AP1000 Evaluation of Candidate LBB Piping Systems

**Presentation to NRC Staff
Rockville, MD**

October 2, 2003

AP1000 DESIGN CERTIFICATION REVIEW

Figure 28 - Bounding Analysis Curve - Normal RHR Suction - 10"

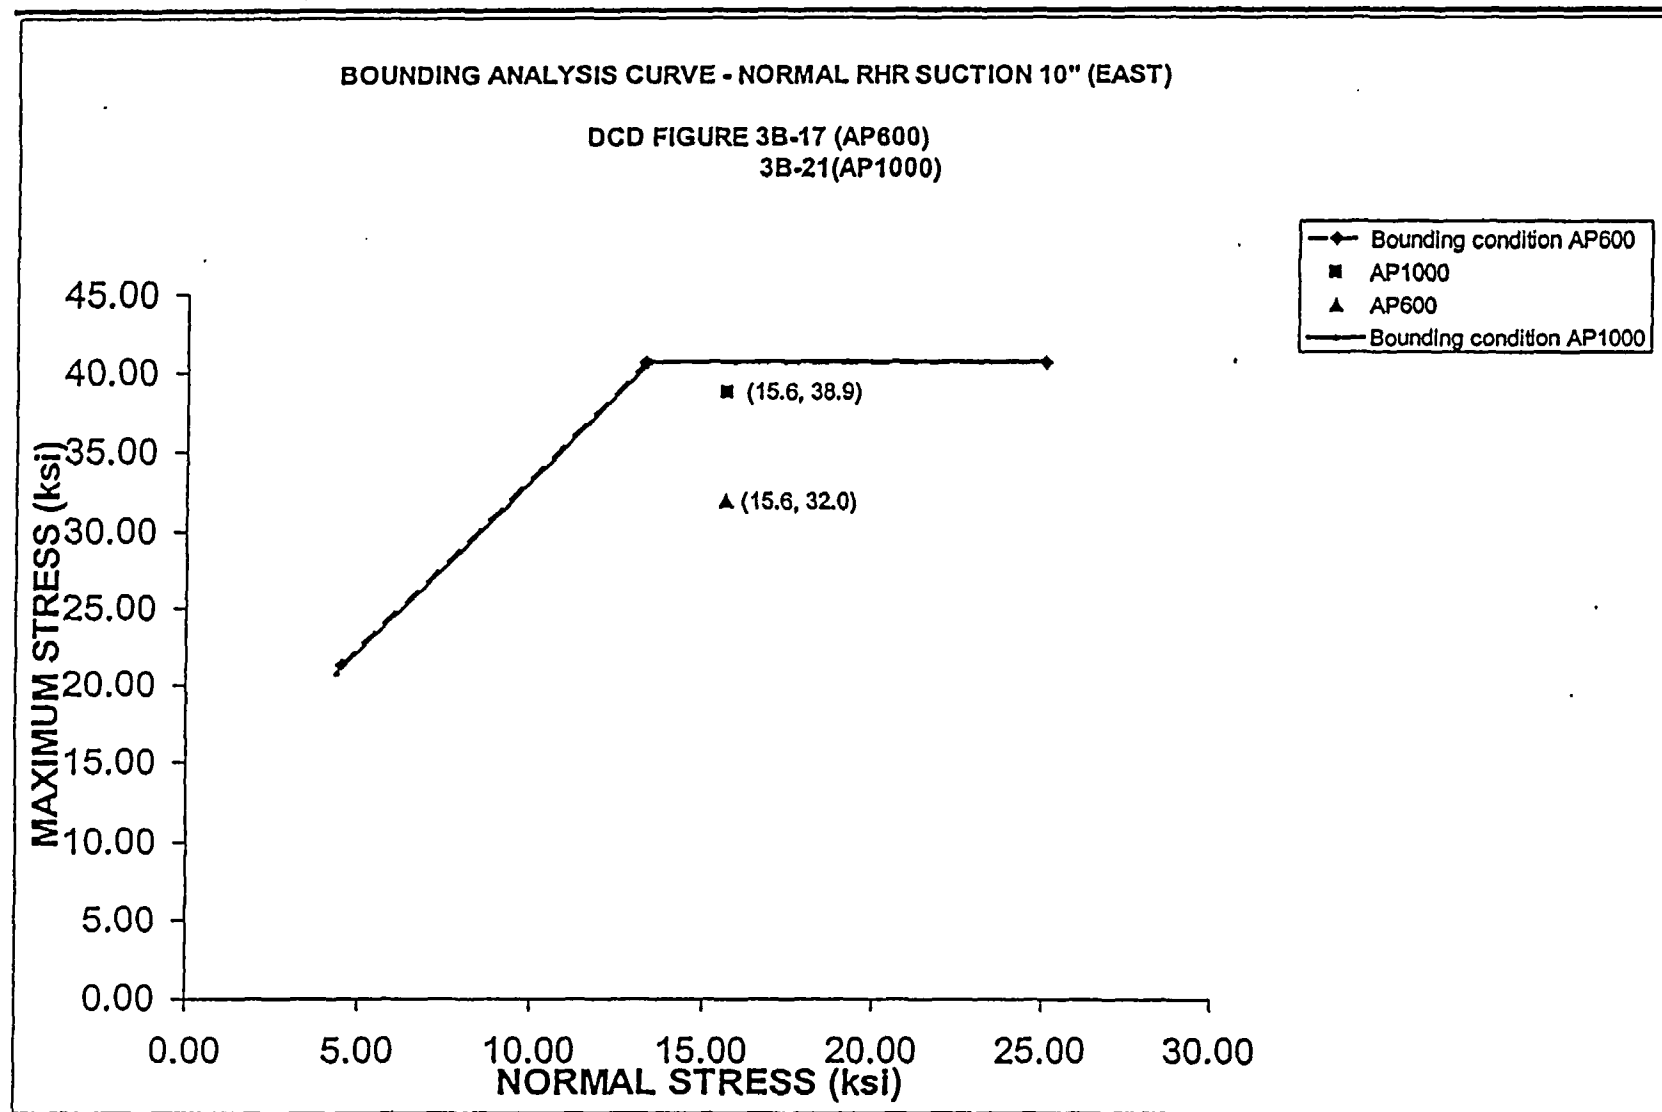
Normal RHR Suction (East) – 10” pipe		
AP600 Analysis	Maximum Stress	30.0 ksi
	Normal Stress	15.6 ksi
	SSE Stress (5% damping)	14.4 ksi
	SSE Stress (4% damping) ⁽¹⁾	16.4 ksi
	Maximum Stress'	32.0 ksi
AP1000 Estimate	SSE Stress (4% damping) ⁽²⁾	23.3 ksi
	Normal Stress	15.6 ksi
	Maximum Stress	38.9 ksi

- (1) 1.14 increase factor: 5% damping → 4% damping
(2) 1.42 increase factor: AP600 → AP1000 Response Spectra

Figure 29 - Bouding Analysis Curve – Passive RHR Return – 14"

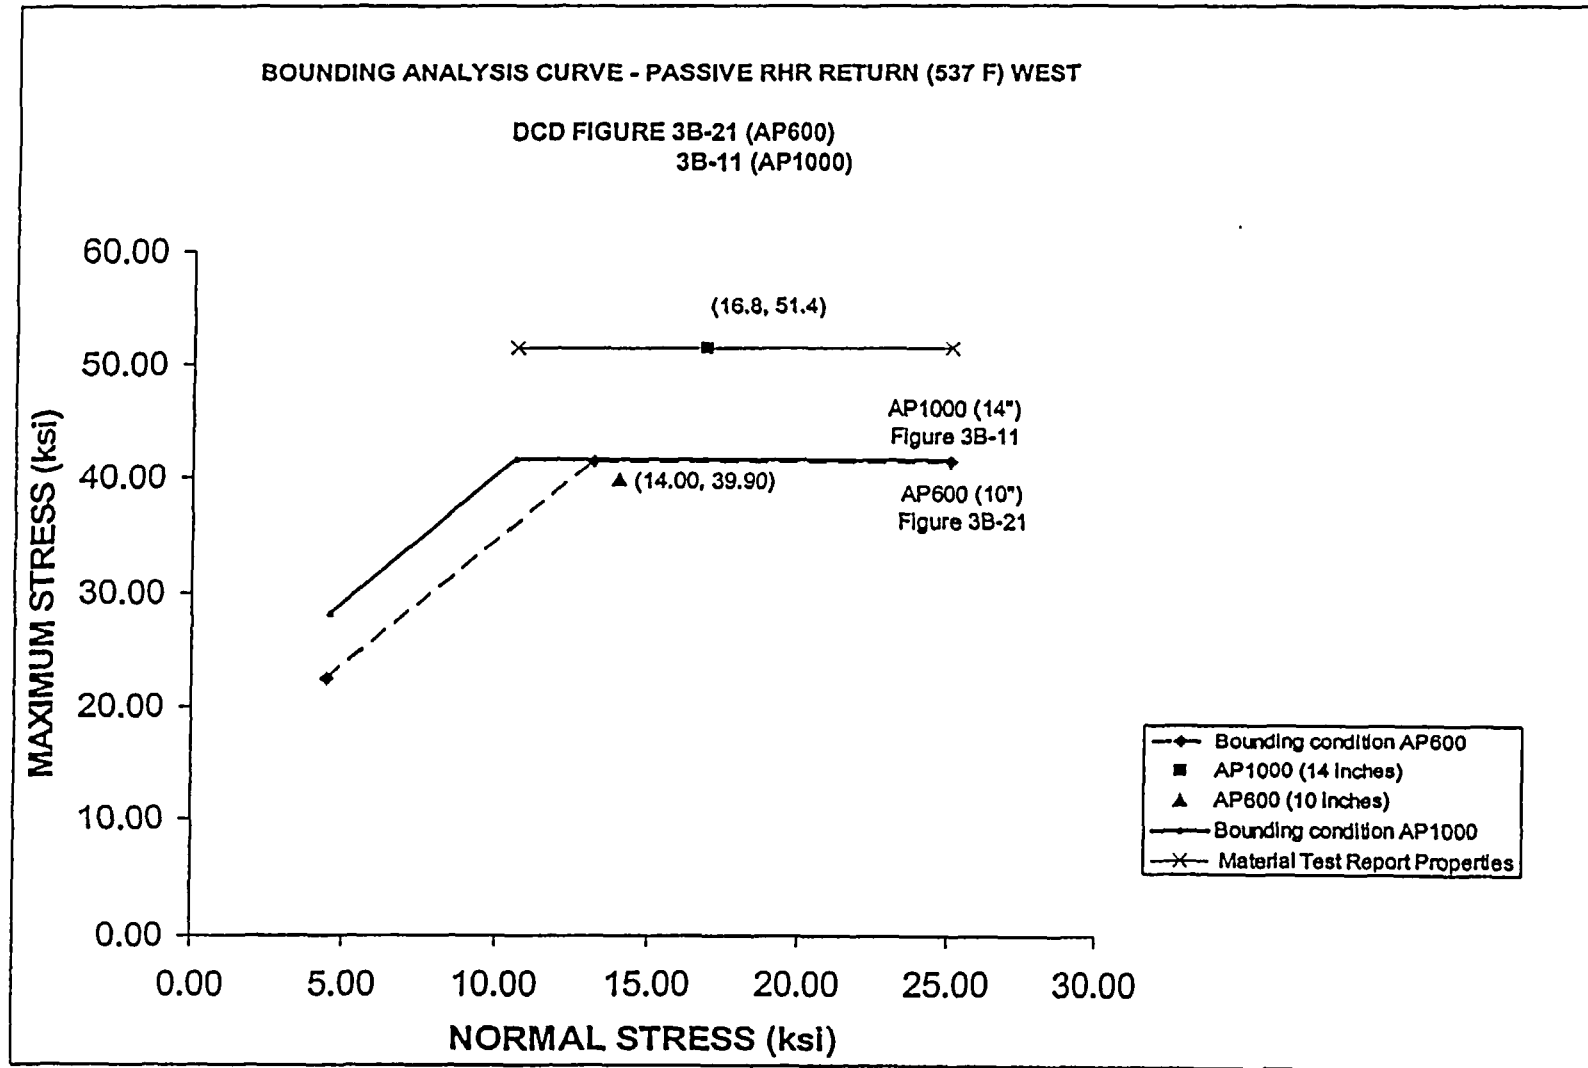
Passive RHR Return (West)		
AP600 – 10" pipe		
AP1000 – 14" pipe		
AP600 Analysis	Maximum Stress	39.9 ksi
	Normal Stress	14.0 ksi
	SSE Stress (4% damping)	25.9 ksi
	Pressure Stress	4.7 ksi
	Deadweight + Thermal Stress	9.3 ksi
AP1000 Estimate	Pressure Stress	4.7 ksi
	Deadweight + Thermal Stress ⁽¹⁾	12.1 ksi
	Normal Stress	16.8 ksi
	SSE Stress ⁽²⁾	34.6 ksi
	Maximum Stress	51.4 ksi

(1) 1.30 increase factor: 10" pipe → 14" pipe

(2) 0.77 reduction factor: 10" pipe → 14" pipe

1.74 increase factor: AP600 → AP1000 Response Spectra

Figure 36 - Bounding Analysis Curve – CMT - 8"

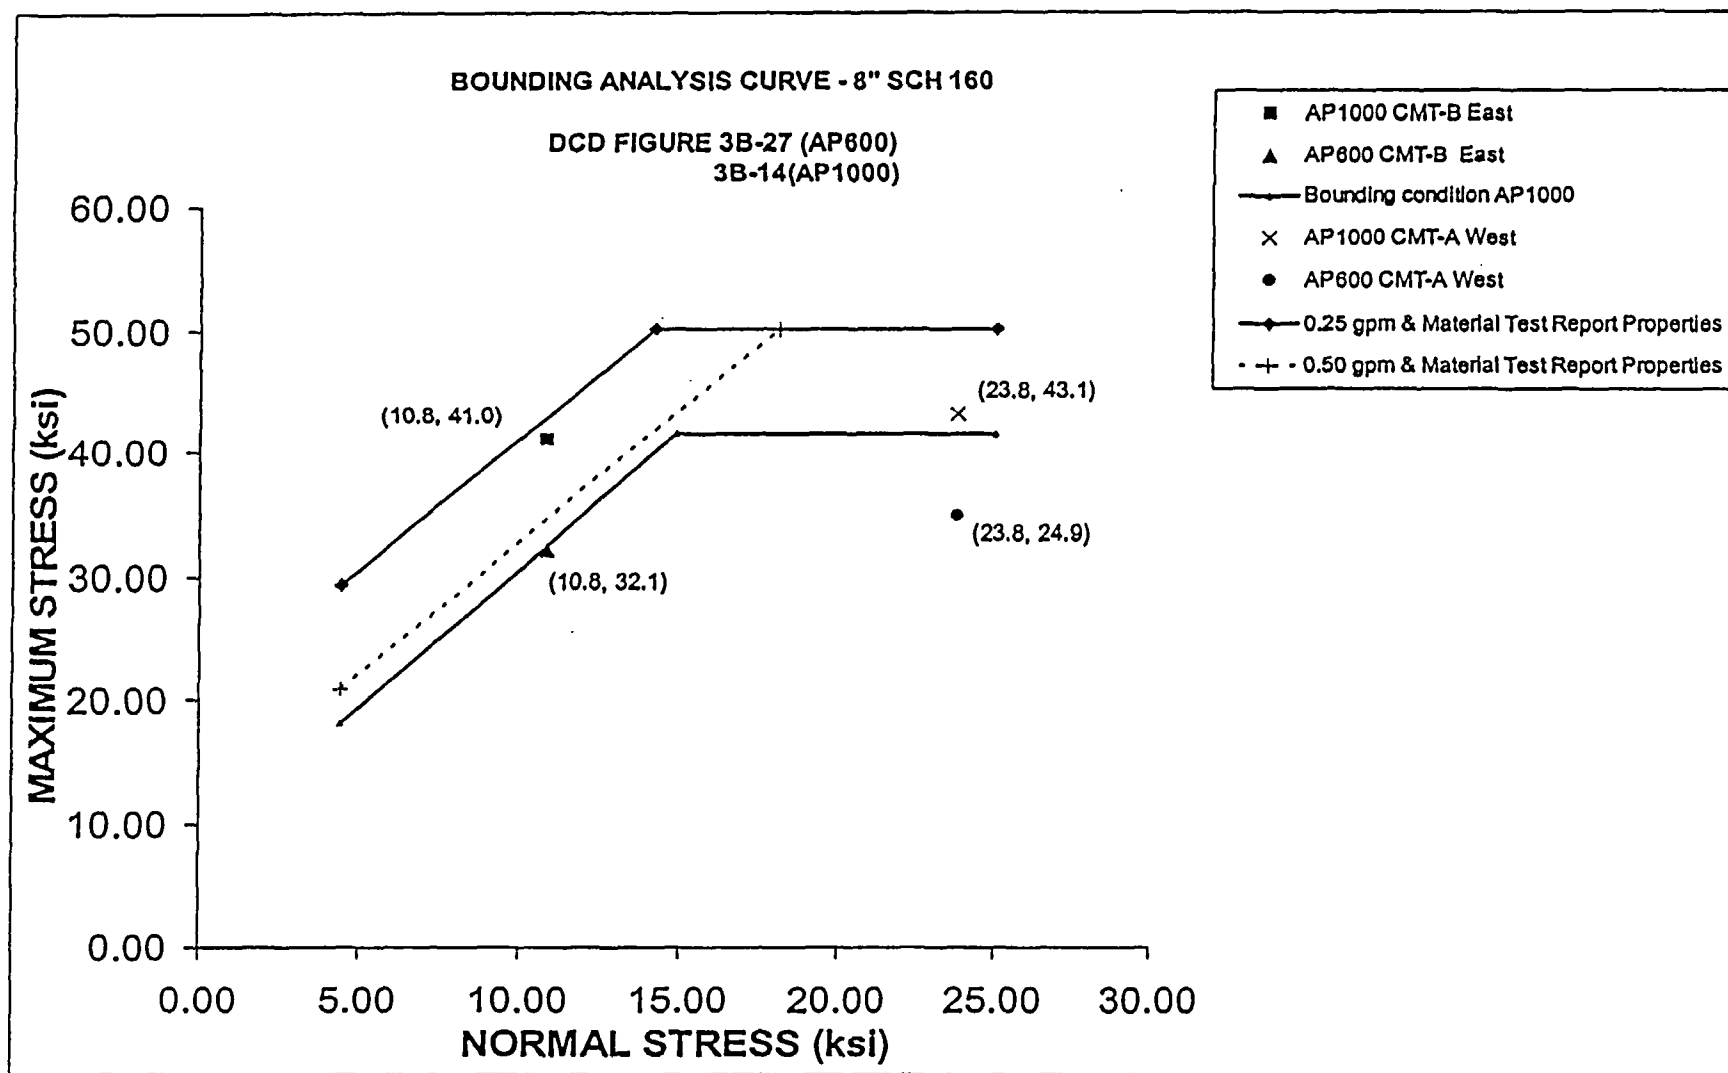
Passive Core Cooling CMT-B (East) – 8” pipe		
AP600 Analysis	Maximum Stress	29.4 ksi
	Normal Stress	10.8 ksi
	SSE Stress (5% damping)	18.6 ksi
	SSE Stress (4% damping) ⁽¹⁾	21.3 ksi
	Maximum Stress'	32.1 ksi
AP1000 Estimate	SSE Stress (4% damping) ⁽²⁾	30.3 ksi
	Normal Stress	10.8 ksi
	Maximum Stress	41.1 ksi

(1) 1.14 increase factor: 5% damping → 4% damping

(2) 1.42 increase factor: AP600 → AP1000 Response Spectra

Figure 21 - Bounding Analysis Curve - Pressurizer Safety - 6"

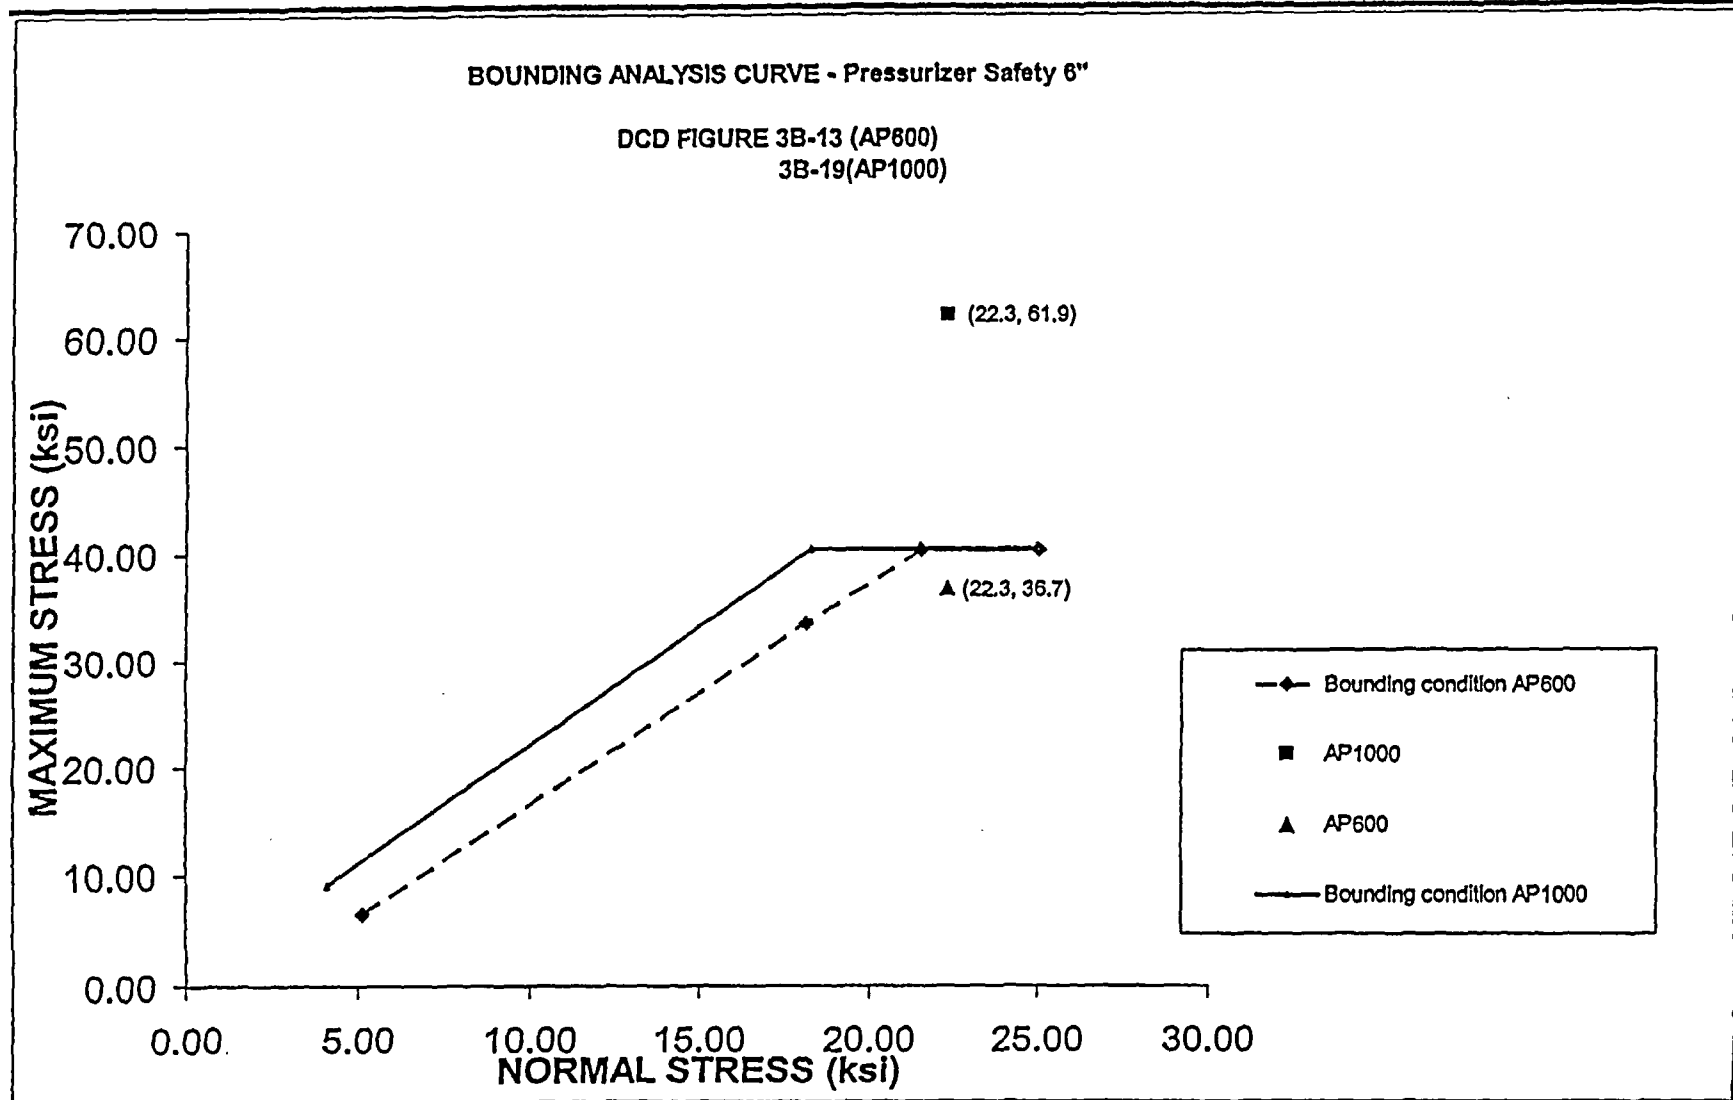
Pressurizer Safety – 6” pipe		
AP600 Analysis	Maximum Stress	36.7 ksi
	Normal Stress	22.3 ksi
	SSE Stress (4% damping)	14.4 ksi
AP1000 Estimate	SSE Stress (4% damping) ⁽¹⁾	39.6 ksi
	Normal Stress	22.3 ksi
	Maximum Stress	61.9 ksi

(1) 2.75 increase factor: AP600 → AP1000 Response Spectra
